# Star Charge Firmware Release Note - E365\_Aries V2\_V2.2703.0 User Unit (Standard)

User Unit : V2.2703.0\_20251112

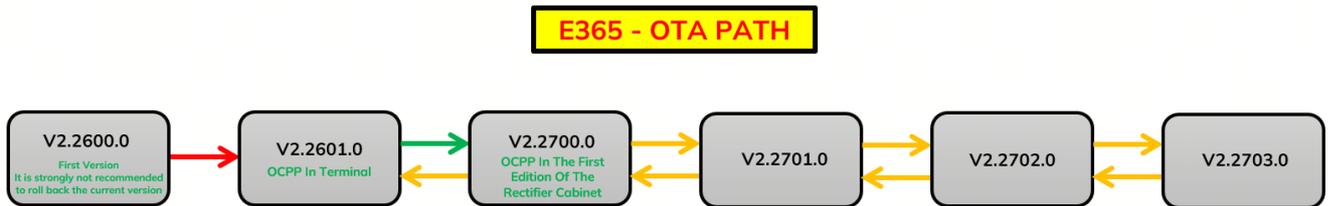
Versions prior to 2.2702.0 cannot be OTA upgraded to 2.2702.0 or later versions. Versions 2.2702.0 and later can be upgraded or downgraded normally (2.2701.0 does not support OTA upgrade either).

Due to the abnormal configuration file issue in version V2.2702.0, it is recommended to abandon it directly and not use in the future. The latest update, version V2.2703.0 requires a full card upgrade.
